SSDA REPORT

North Sydney Public School 182 Pacific Highway, North Sydney NSW 2060

Report Prepared for: Department of Education
Report Prepared by: Lucy Alderson
Our Ref: AN021-216878 SINSW
Date: 27 August 2021

DRAWING NUMBER
SD-2005

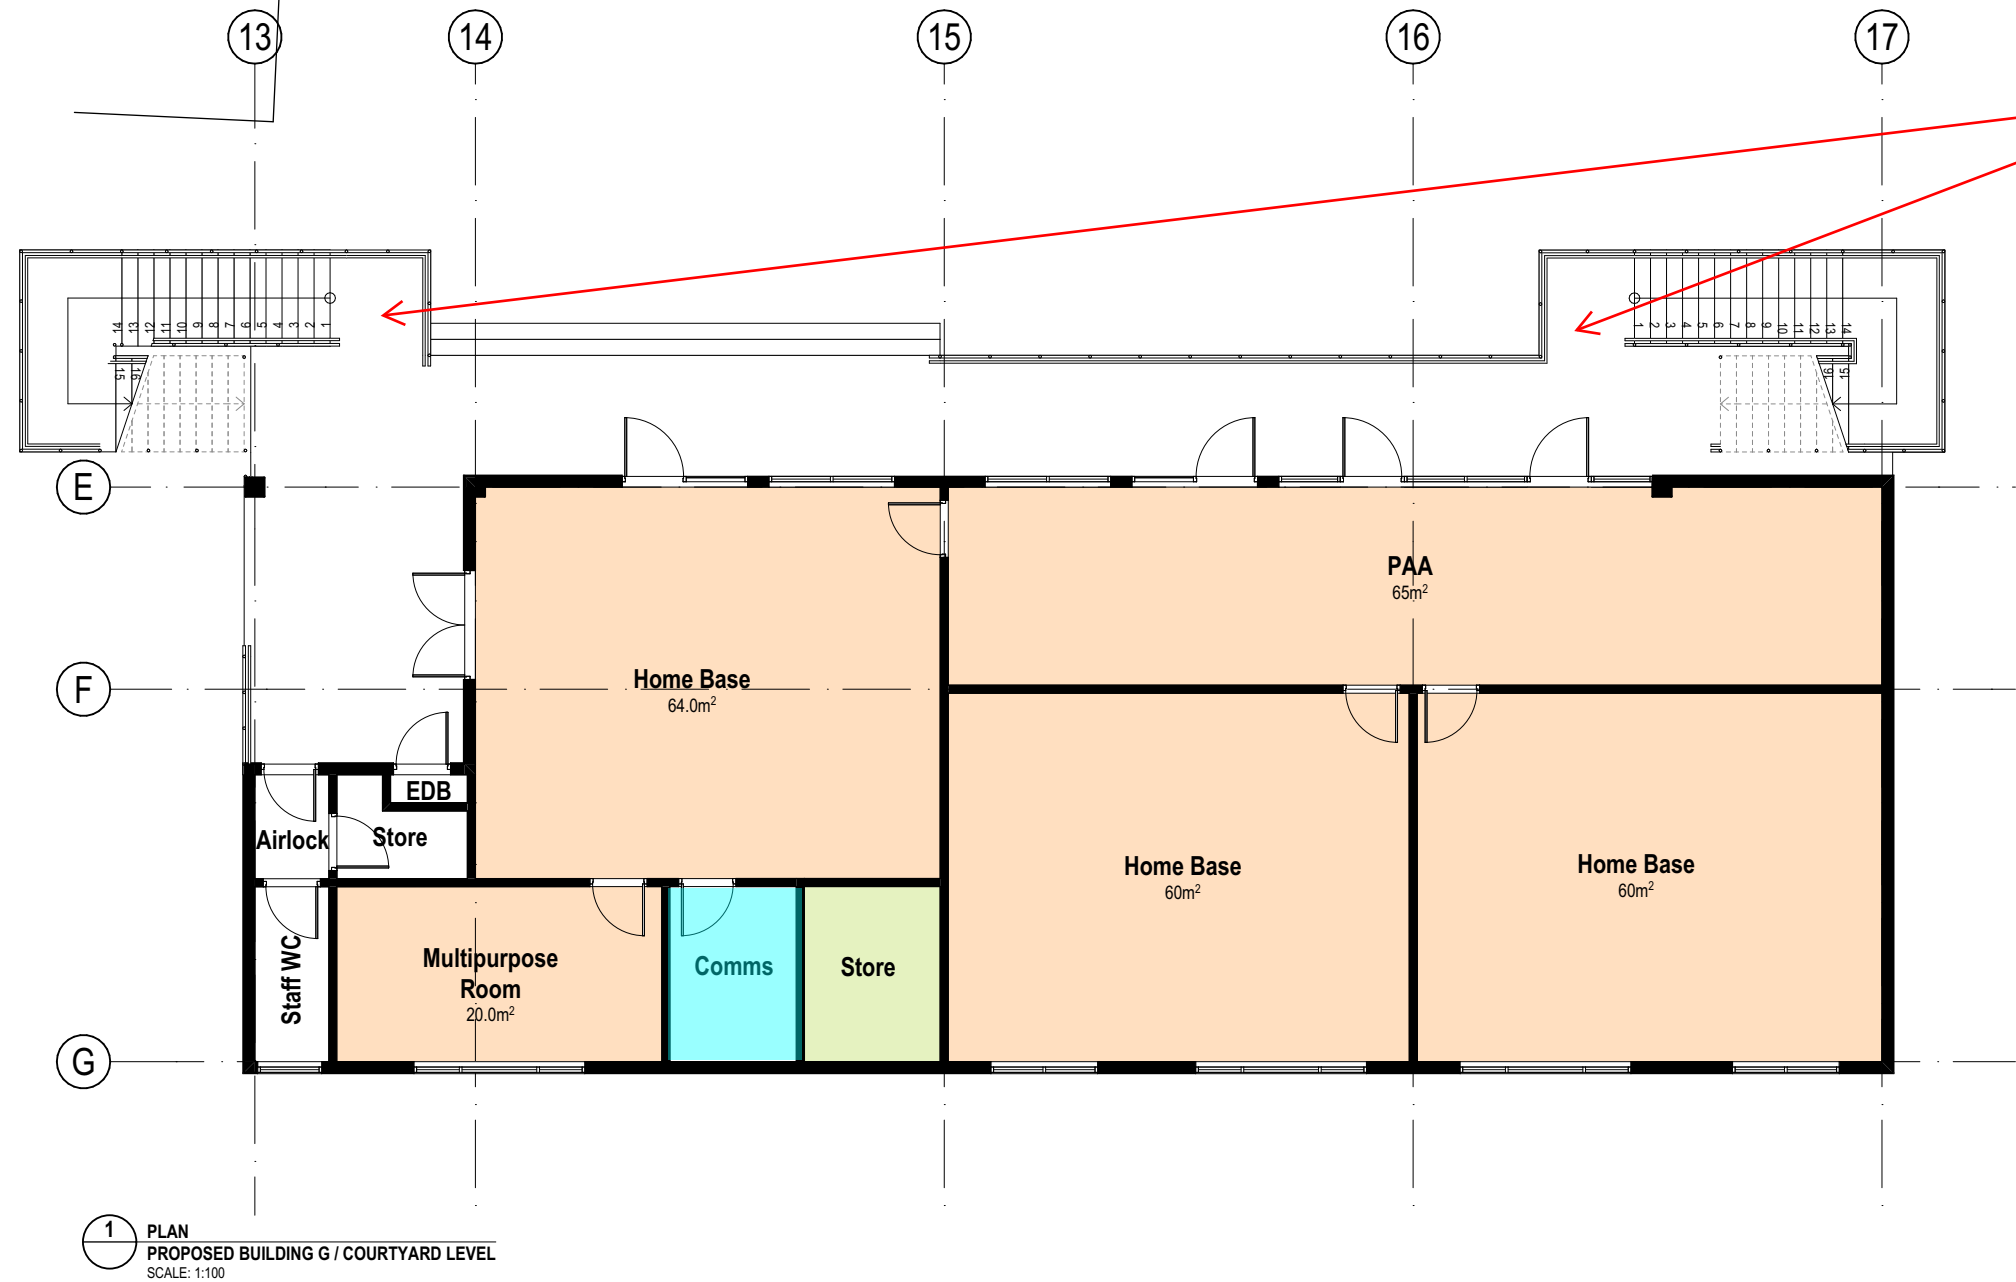
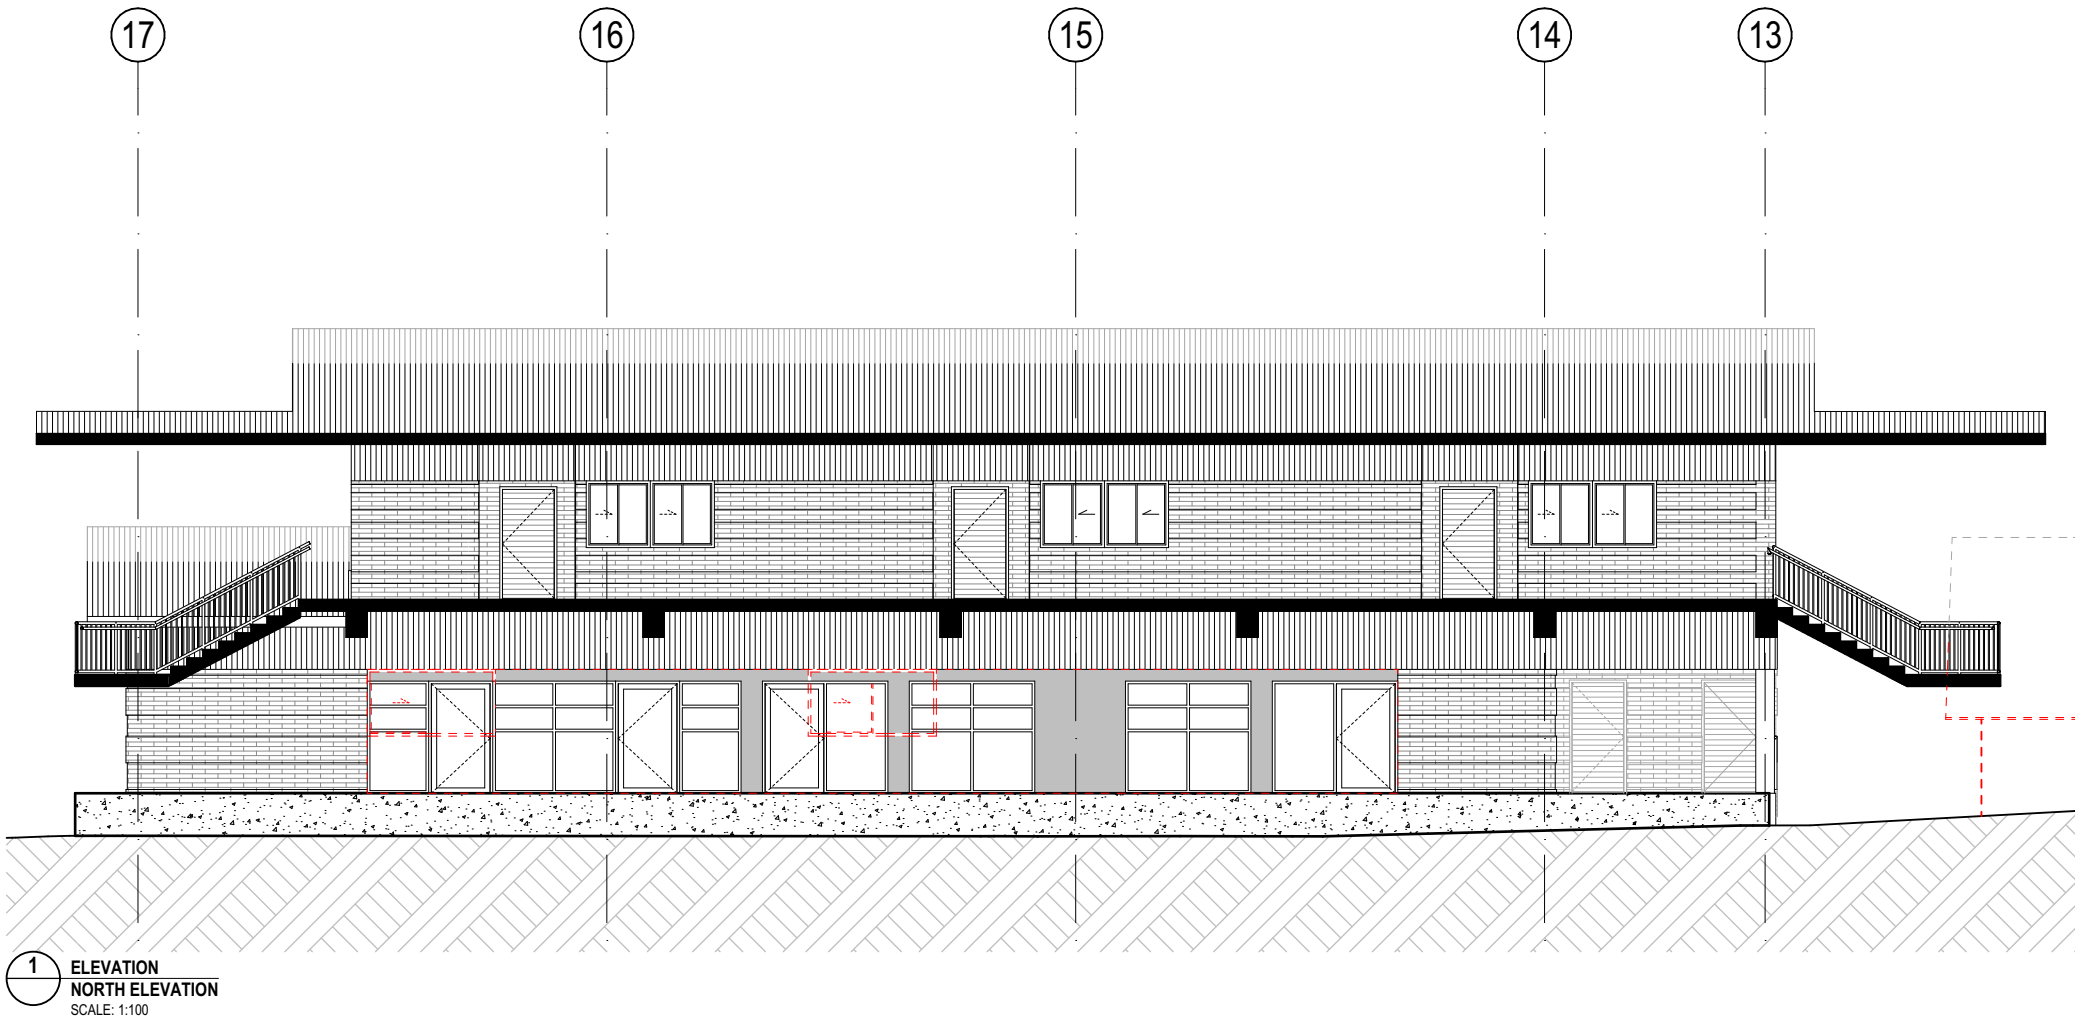
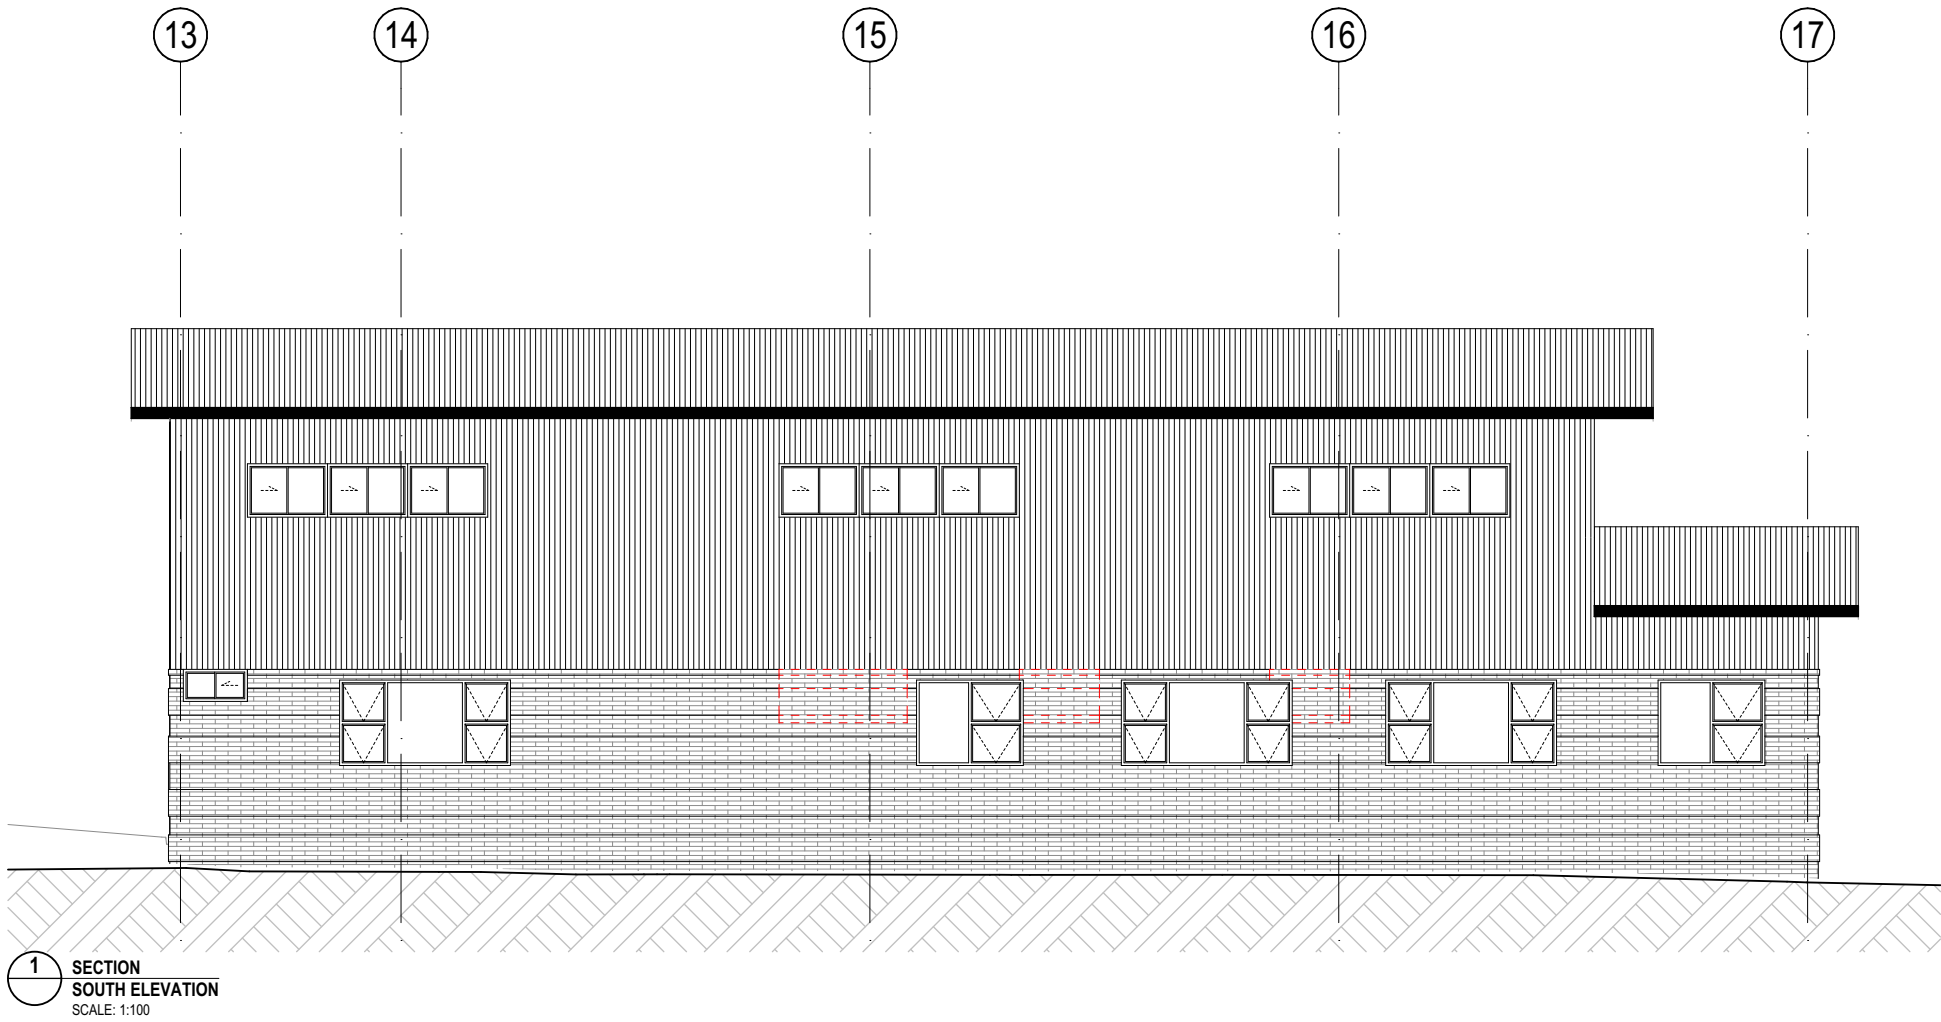
Stairways - AS1428.1 (2009), Clause 11
Designers to ensure stair details meet the requirements of AS1428.1 - 2009 Clause 11, including handrail extension and TGSI's at the top and bottom of each stair.

Stair setbacks
Ensure adequate stair setbacks are provided to prevent the handrail extensions (top and bottom of stairs) from protruding into the transverse path of travel.
